Conceptual Engineering Report DRAFT

VALUE PLANNING STUDY REPORT

Value Planning Workshop for

the Proposed
Detroit River International Crossing

*DRIC - Possible Plaza/Ramp Configuration
Interchange Alternative 4 (Idea 33)*

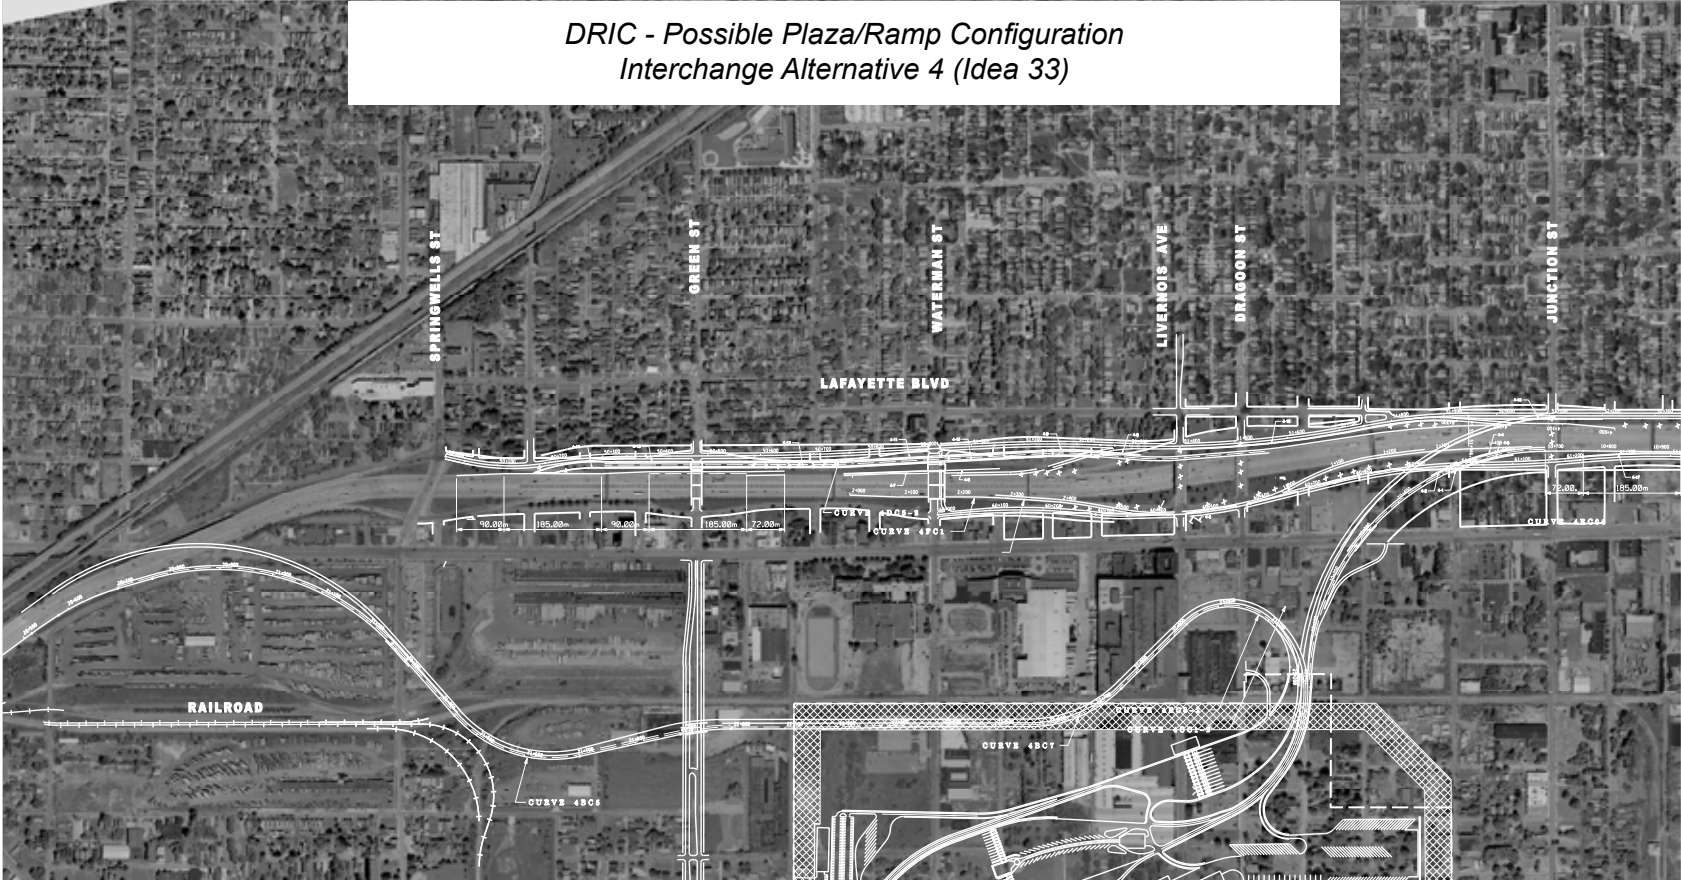
7. Add Items to Improve Public Acceptance of Interchange Alternate 4, and others
Accept for Further Study
Although Alternate 4 did not rank as high by the VE/VP Team, they suggested that adding low-cost factors might change the Acceptance Matrix score and thus rate this alternate higher. Adding Public Acceptance features to other alternates might also raise their VE/VP Acceptance scores.

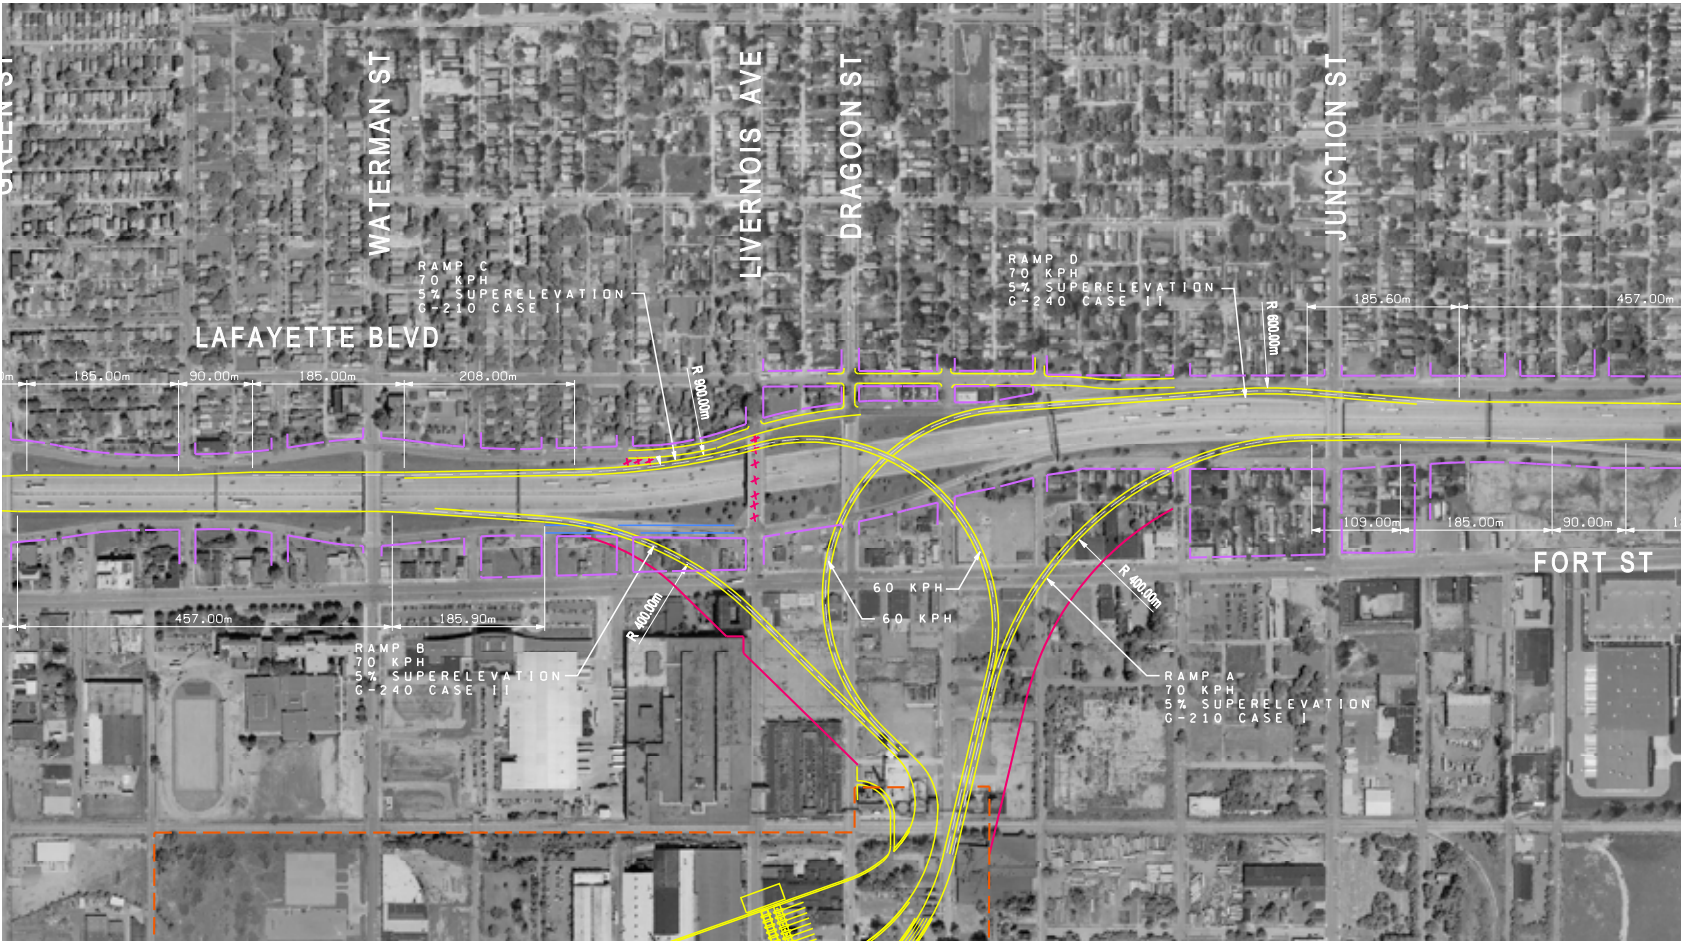
- Maintains Clark and Springwells Interchanges
- Localizes the impacts to service drives
- Requires less Right-of-Way
- Reduces impacts north of I-75
- Slows traffic entering the Plaza

- Design Speed of 30 mph in circle
- Close Livernois Bridge
- Close Livernois / Dragoon Interchange

The exits and entrances around Waterman St. and Junction St. will follow the applicable MDOT Standards and would be able to provide the required acceleration and deceleration distances. The exit and entrance ramps to and from the I-75 freeway will be designed to 70 kph (45 mph). However, within the circle, the proposed interchange has a minimum radius of 150 meters with a corresponding design speed of 50 kph (30 mph) for a 6% superelevation design (Based on MDOT Standard R-107-D1, page 1).

Due to the need to decelerate and stop before entering the Plaza, it is assumed that this configuration could work with the minimum radius of 150 and still provide a free flowing traffic. Further traffic studies can be performed to determine the viability of this geometry.

VP Interchange 1 requires the closure of the Livernois/Dragoon interchange and the closure of Livernois Ave. Bridge. The SB entrance to I-75 from Livernois and the NB Exit to Livernois are also closed. Dragoon St. can be kept open by raising the SB entrance ramp (Ramp C) and the SB exit ramp Ramp D that both go over I-75. The initial plan is to let Ramp D go under Ramp C and both ramps are over I-75 and Dragoon St. Profile investigations and

To provide continuity to the service drives, the SB Service Drive will be realigned and the NB service drive will be re-constructed to go under the NB I-75 exit to the Plaza (Ramp B). Other entrance and exit points to the service drives will have to be investigated.

1. **New Interchange Concept VP1 at I-75: Circular Interchange**
Accept for Further Study
This is a circular multi-level full-movement interchange approximately opposite Dragoon Street, that retains the current adjacent Clark and Springwells interchanges. A short segment of SB Service Road could be added to the VE interchange to restore SB Service Road continuity. A variety of public or private uses could be made of land within the circle ramps.

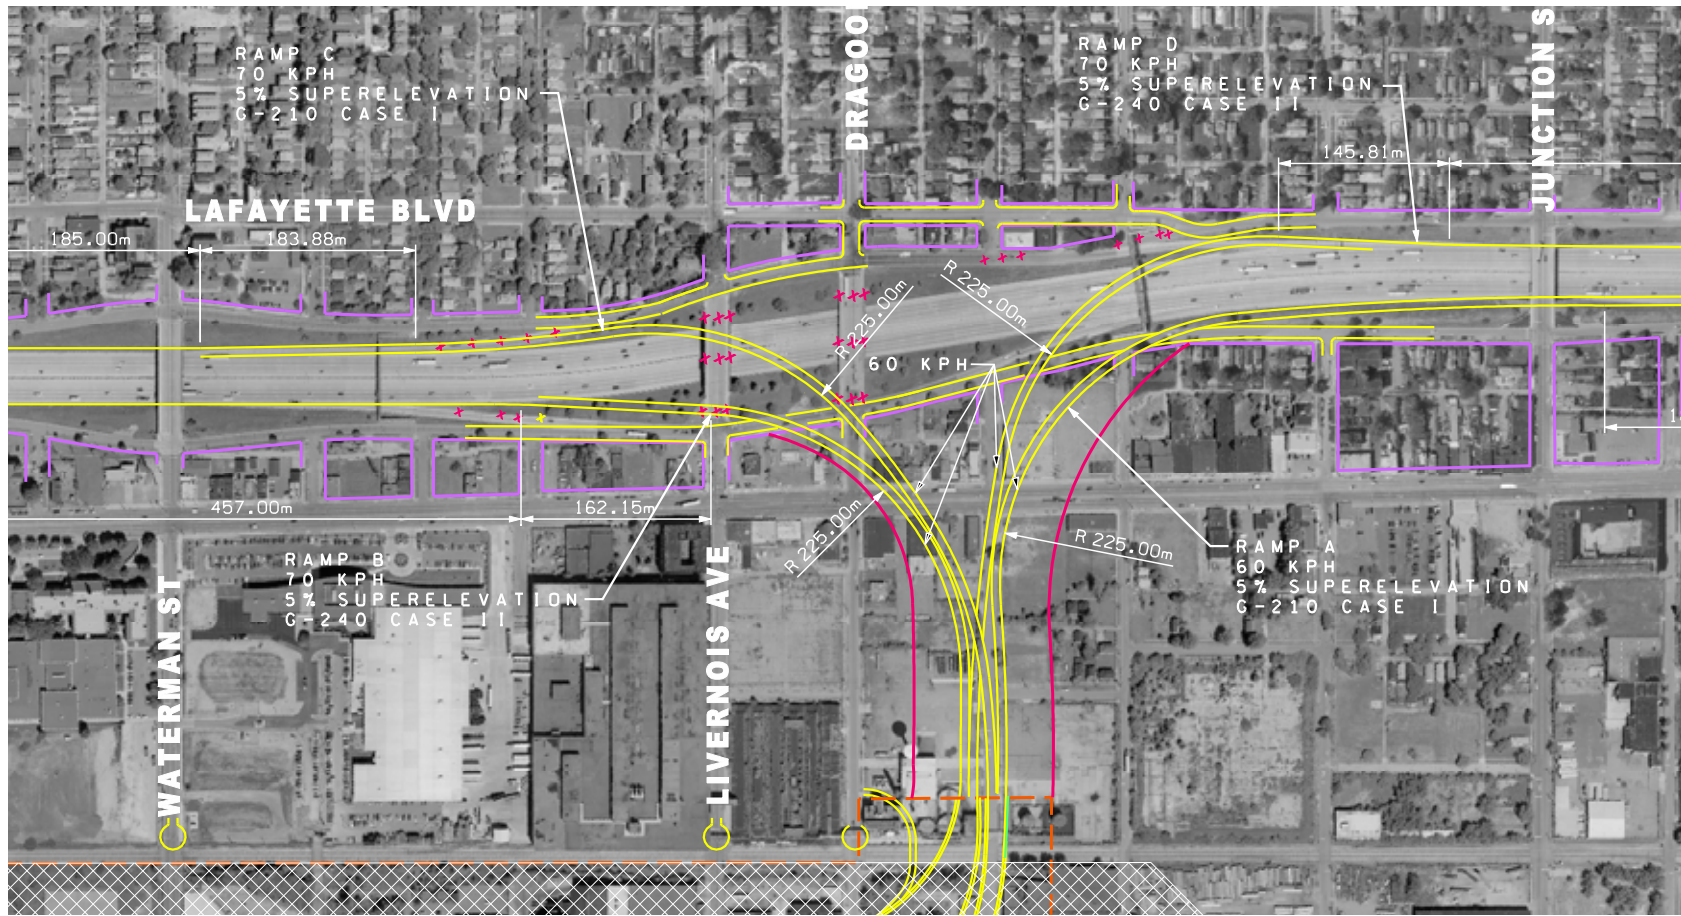
This interchange provides a free flowing traffic utilizing minimum radii of 120m and braiding the ramps to and from the plaza. It is believed that the radii can be increased to 150m to provide a 30 mph design speed.

It is assumed that this configuration could work with the minimum radius of 120 to 150 meters and still provide a free flowing traffic. Further traffic studies can be performed to determine the viability of this geometry.

Other entrance and exit points to the service drives will have to be investigated.

Profile investigations and other geometric calculations need to be performed to validate this alternative.
